SERVICE BULLETIN

Title: Helmets - Microlight - Type: Icaro

Identification	SB-012
Status	Active
Issue	1
Issue Date	27 September 2011 Revised 6 th February 2011
Applicability	Icaro microlight helmet
Compliance	Mandatory

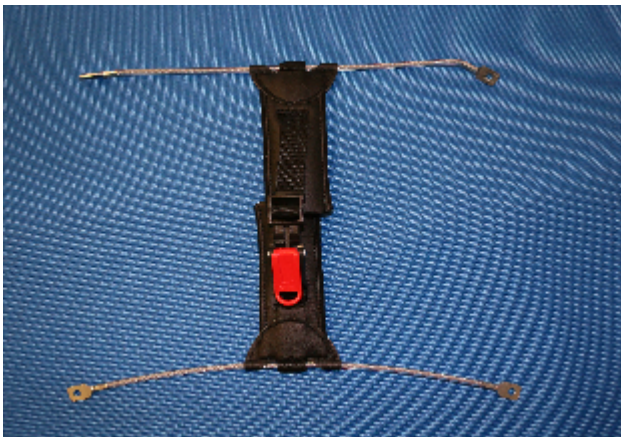
It has been brought to our attention that the wire loops that hold the chin straps on Icaro Microlight helmets can fail. The failure point has been close to where the wire attaches to the helmet. It can start with a broken strand in the stainless steel wire.

To inspect this you simply remove the inner lining of the helmet and bend the wire to see if any strands are broken. If you find any damage to the wire do not use the helmet. A broken wire will cause the chin strap to come away and could result in the helmet falling from the head whilst flying.

UPDATE: Icaro have supplied thicker replacement rope loops with chin straps and screws to attach them. To get replacement the replacement: Contact spares@airborne.com.au or call +61 (0)2 49 449 199 and ask for spares.

The plastic coated wire loops that were found to be faulty were used in a busy commercial operation. We recommend replacement and in the very least a regular pre flight of your equipment.
